As-built Baseline Monitoring Report

**Stony Fork Restoration Site
Upper Neuse River Basin - 03020201
Monitoring Year 00
DMS Contract 6830
DMS Project Number 97085**

Date: August 7, 2019
To: Lindsay Crocker, DMS Project Manager
From: Adam Spiller, Project Manager
KCI Associates of North Carolina, PA
Subject: MY-00 Monitoring Report Comments
Stony Fork DMS #6830, Contract 006830
Neuse River Basin CU 030202018
Johnston County, North Carolina

As-Built Drawing Comments:

Longitudinal Profile
Stony Fork - T1-A
Monitoring Year 00, 2019

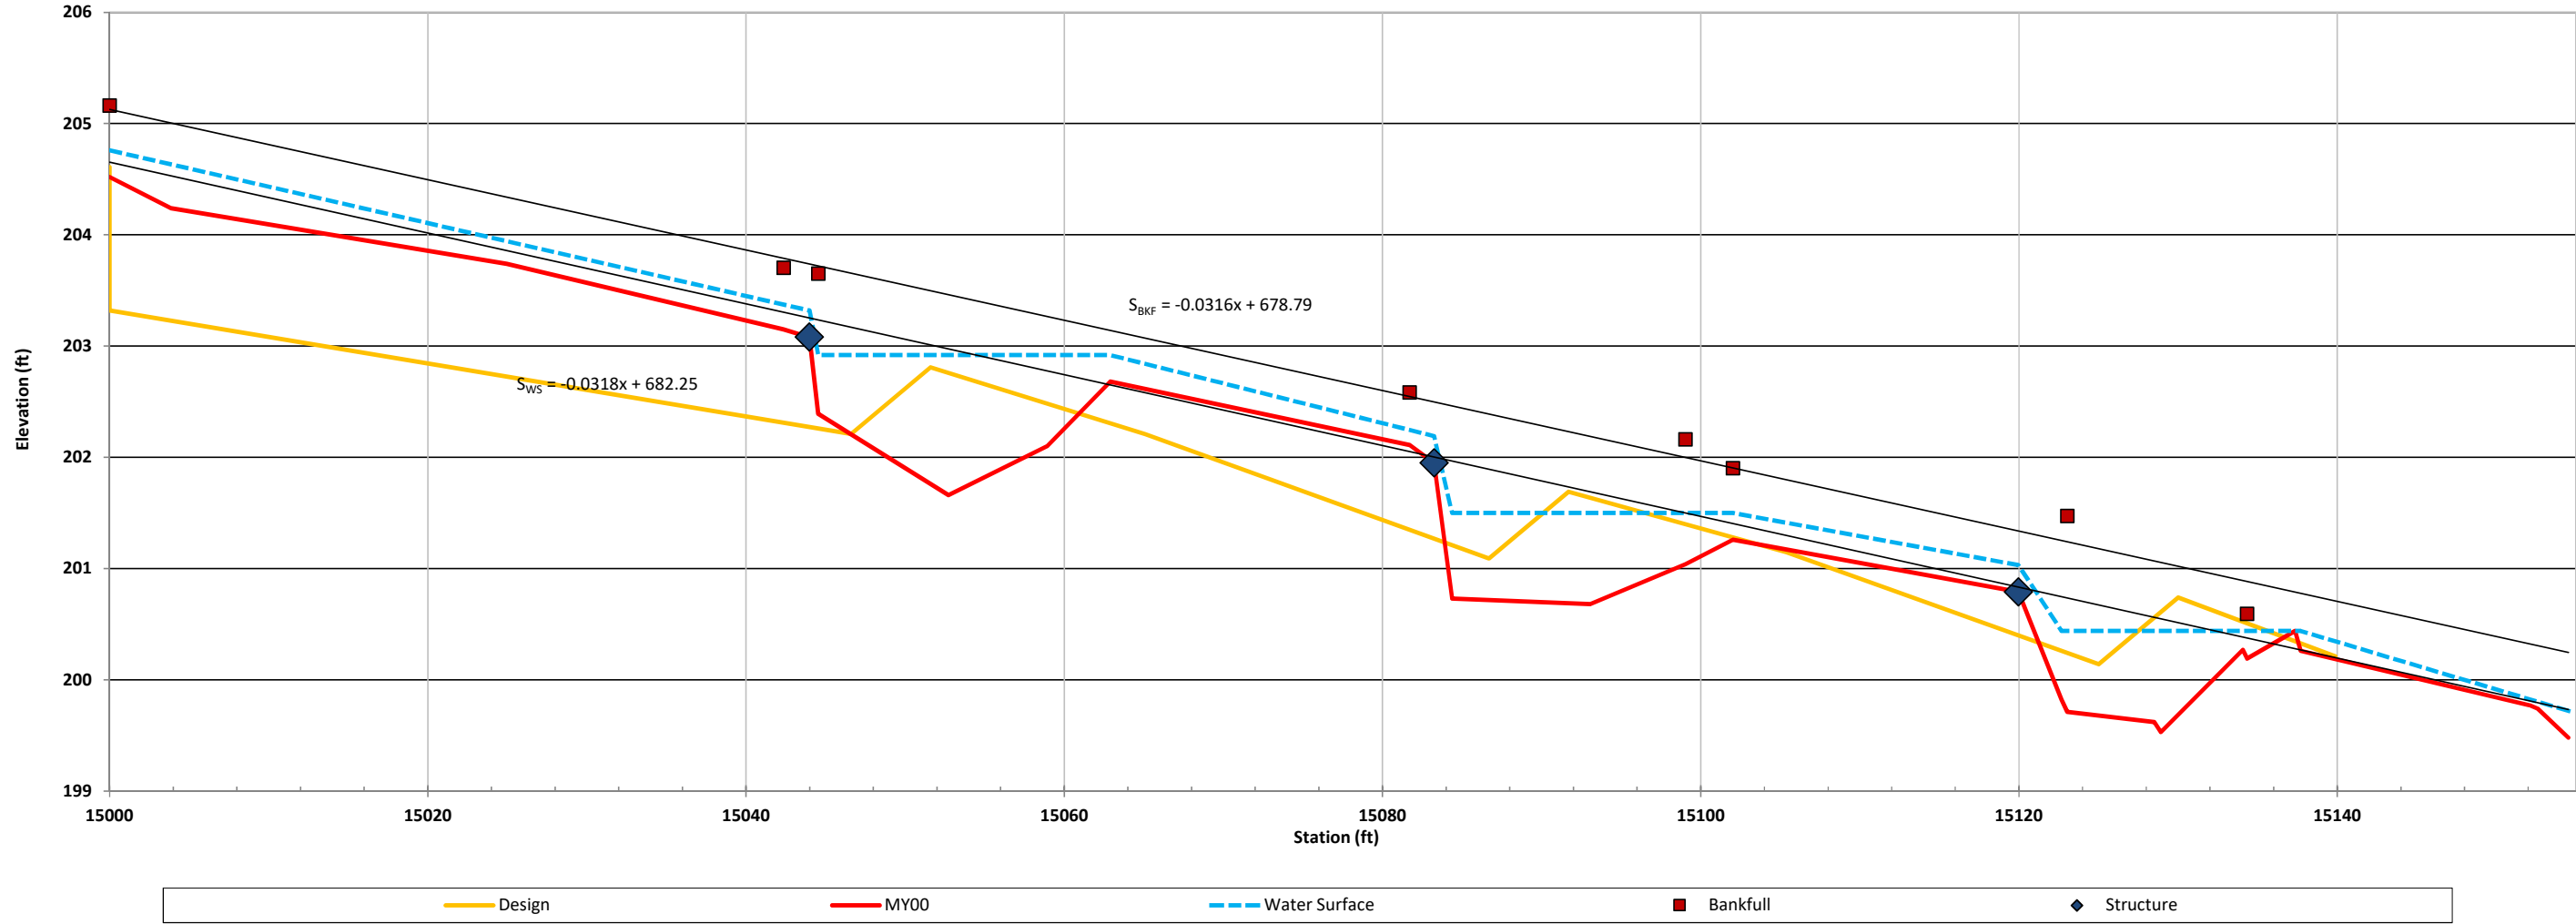
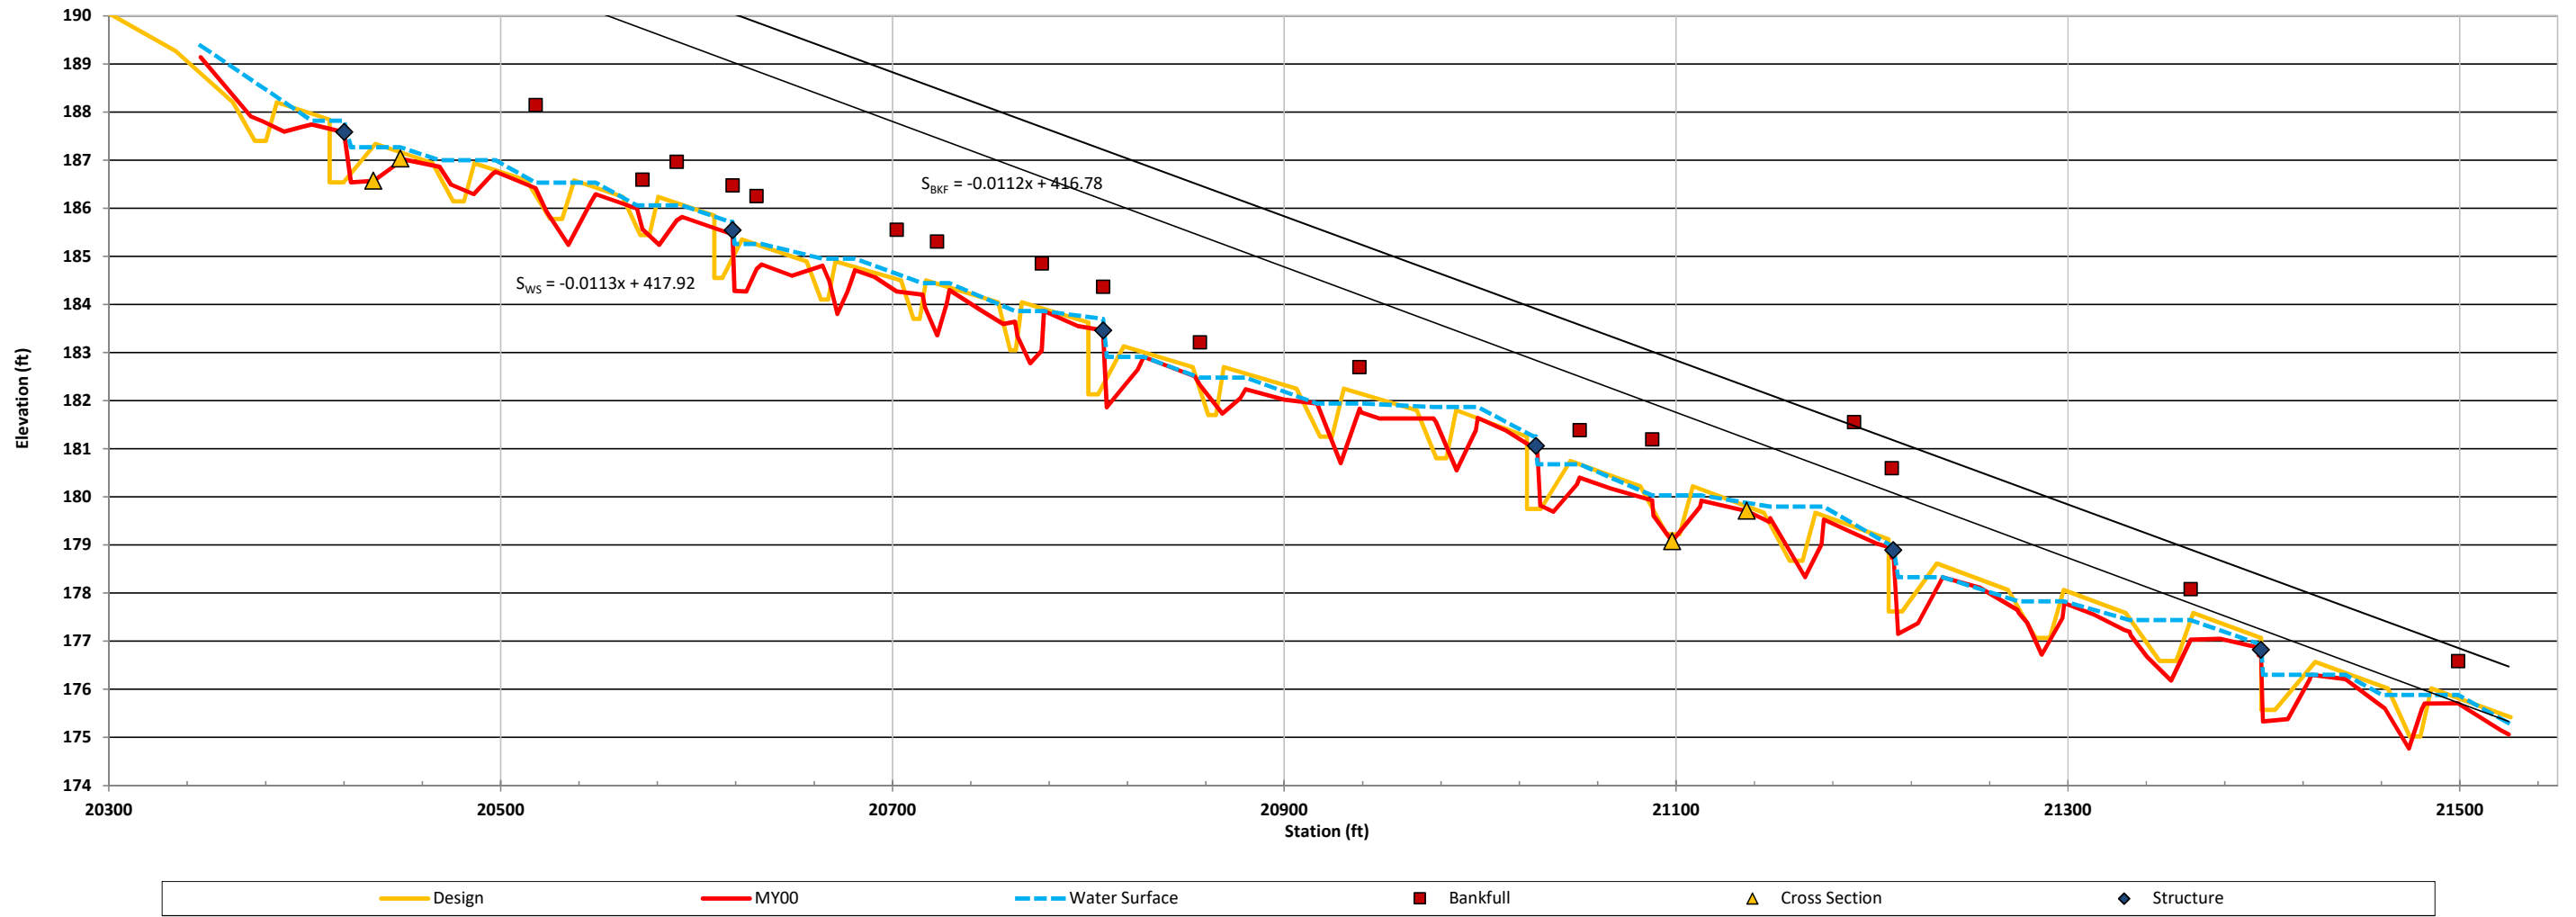
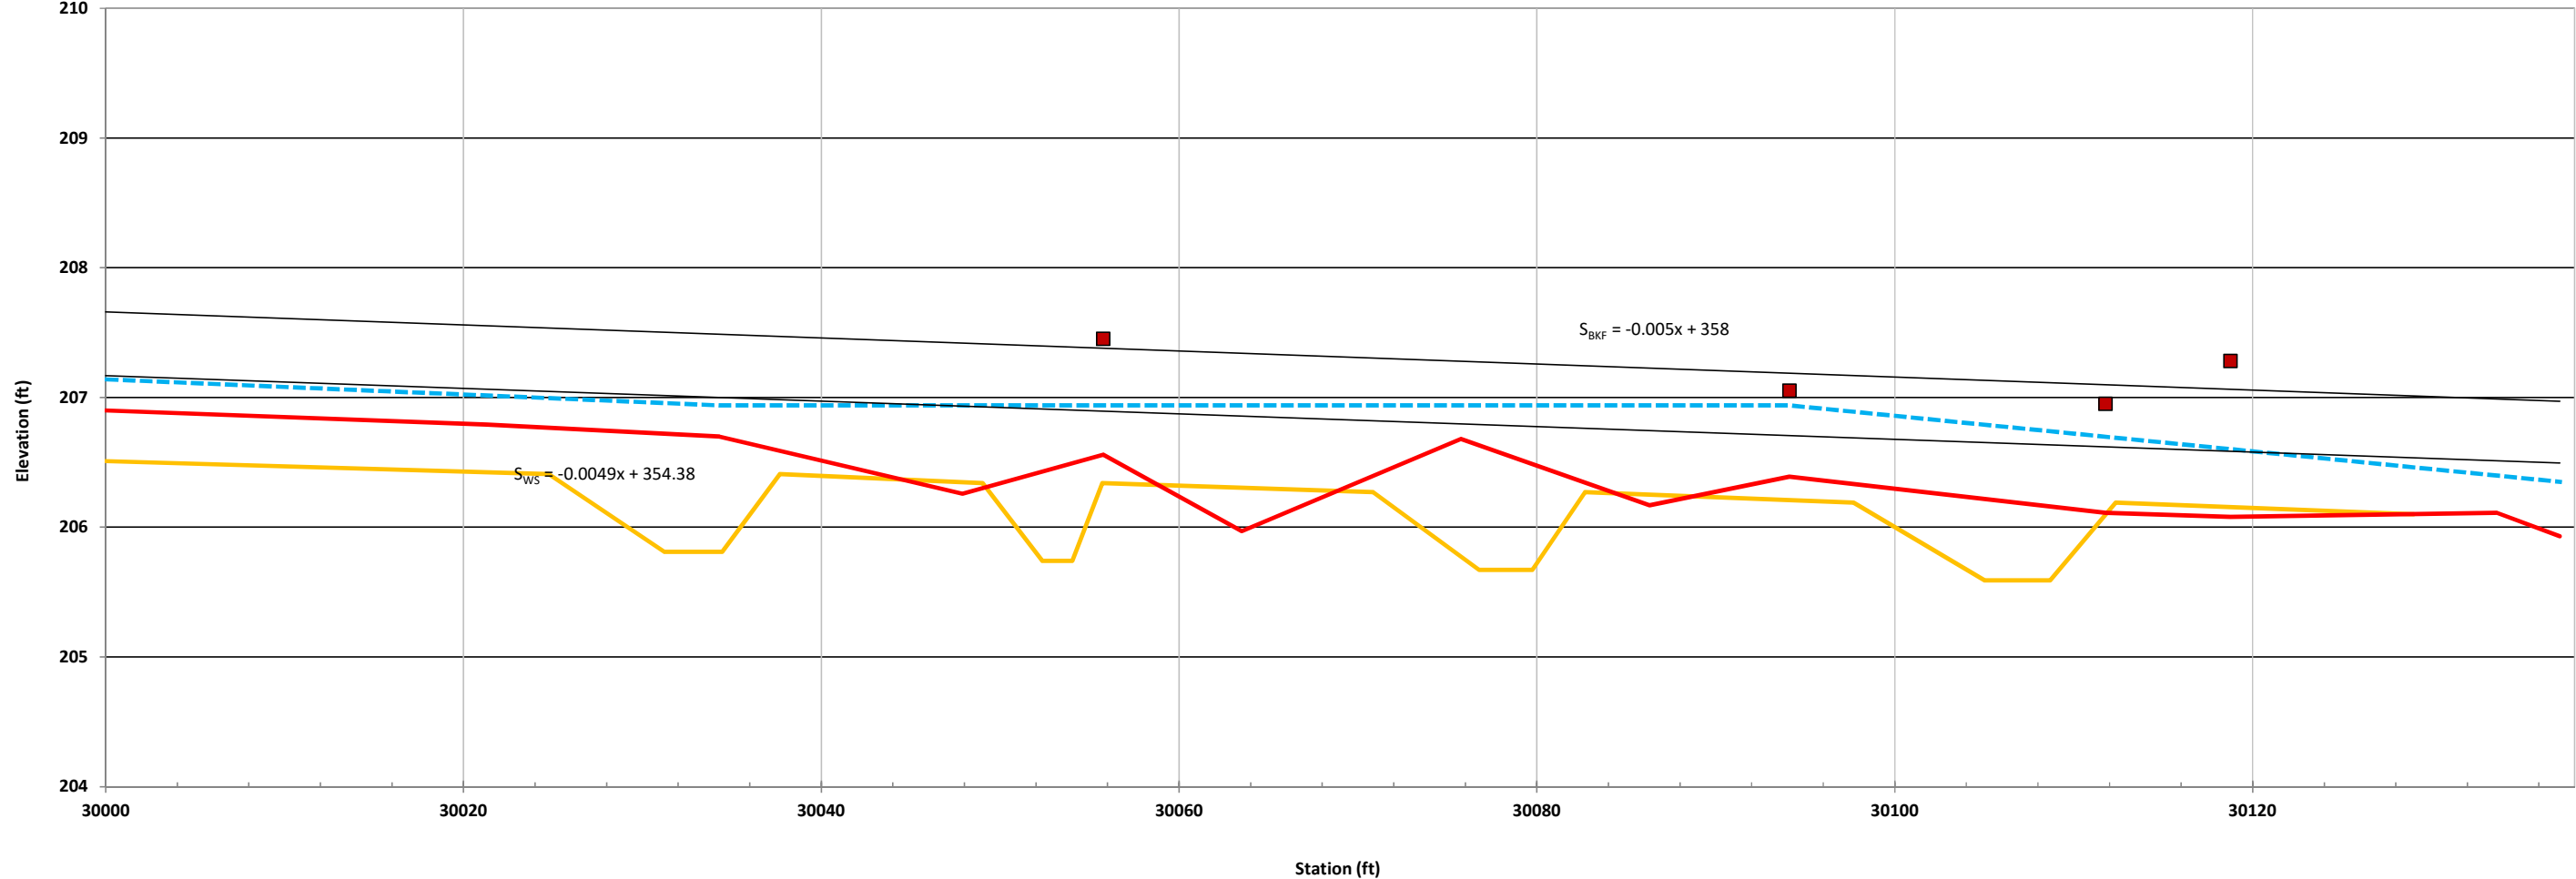
- Long-pro: can you overlay design thalweg? This appears to show in the legend on a few reaches, but it not visible.
 - *This change has been made.*
- Table 1. Please re-name the 'Restoration Footage' column to 'As-Built Restoration Footage.' Provide a column to the left of 'Restoration Footage' that shows the 'MP Restoration Footage' (DMS understands there are slight differences on SF2 and SF3). Make a footnote that project credits are based on Mitigation Plan credits. There is a lot of confusion as to what the IRT would like to use for crediting, and DMS would like to make the numbers as visually clear as possible.

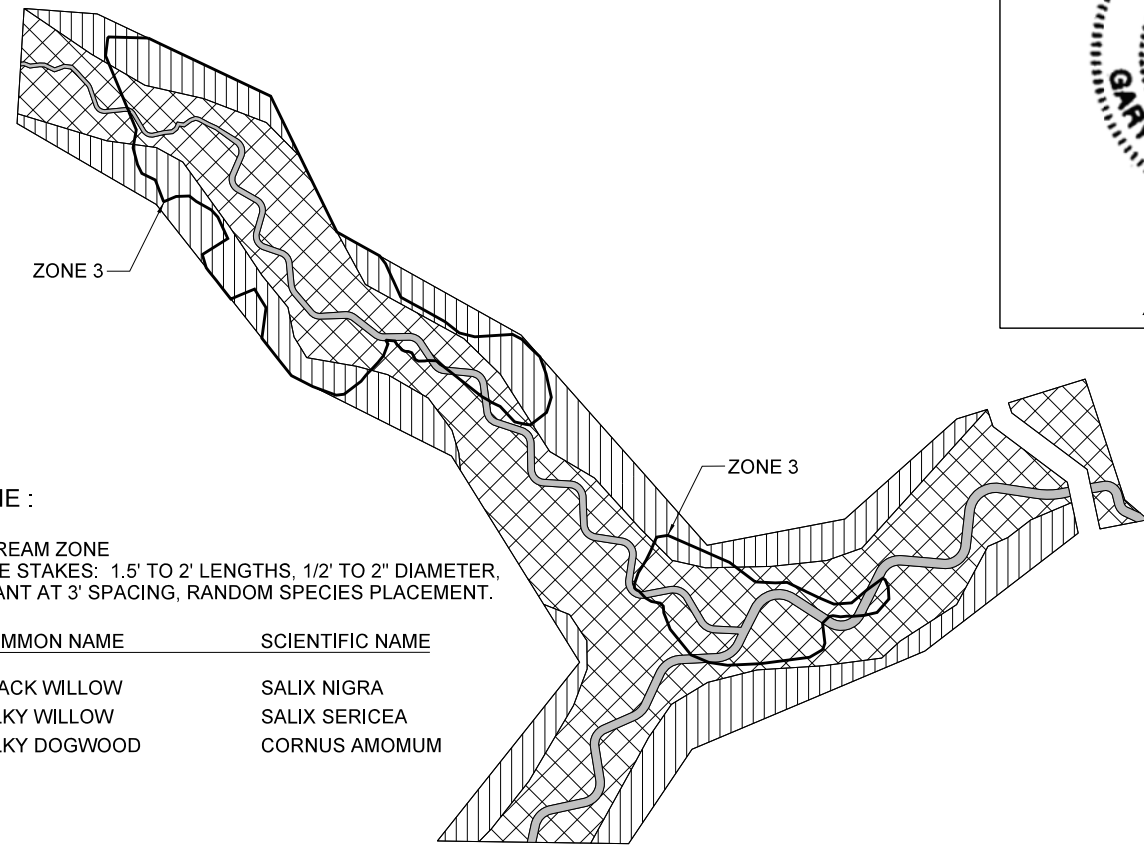
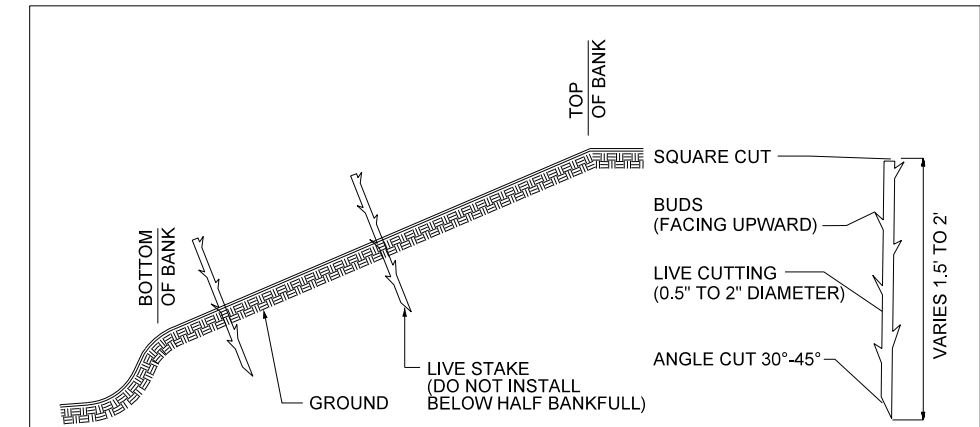
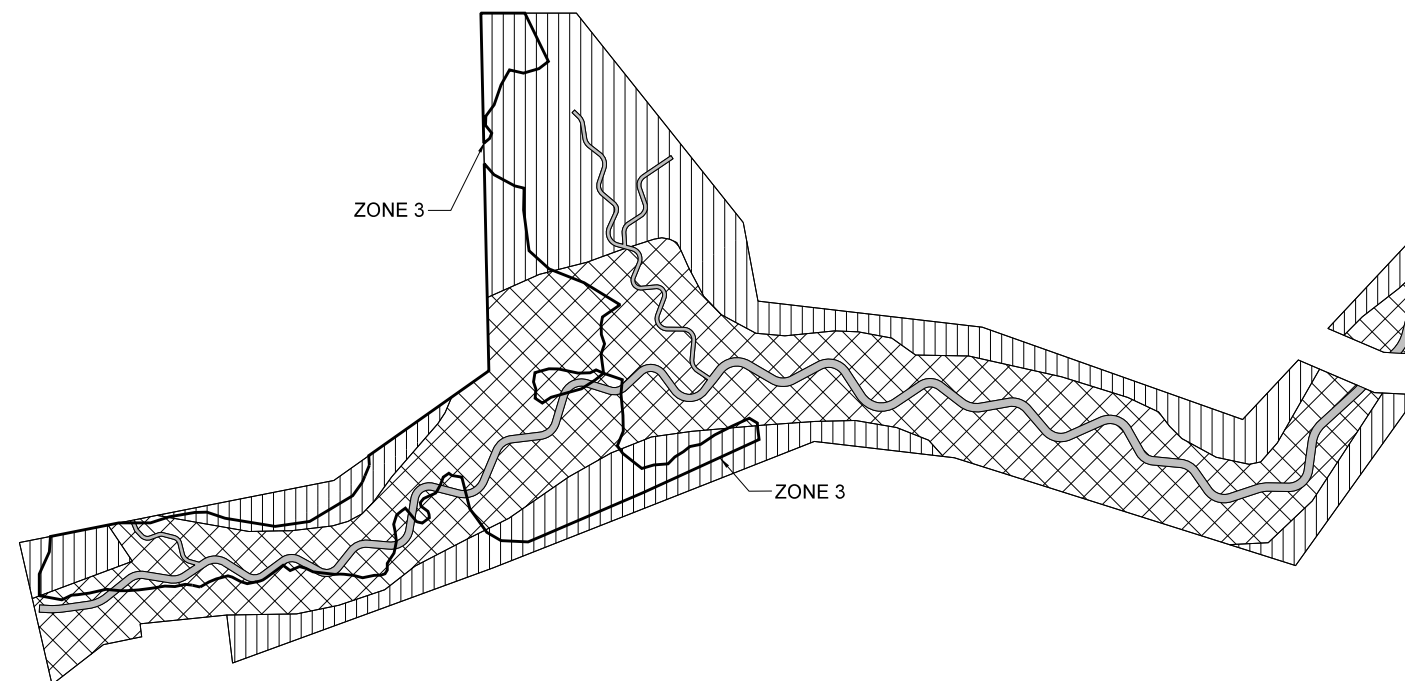
- Vegetation: the table of planted species in the as-built drawings doesn't match some of the shown planted vegetation on Table 6. Please update the table on as-built drawings to include additional planted (and red-line additional spp. as necessary).
 - *This As-built drawings have been updated to reflect the actual number and species that were planted at the site. In addition, several stems classified as planted stems in Table 6 have been re-classified as volunteers.*
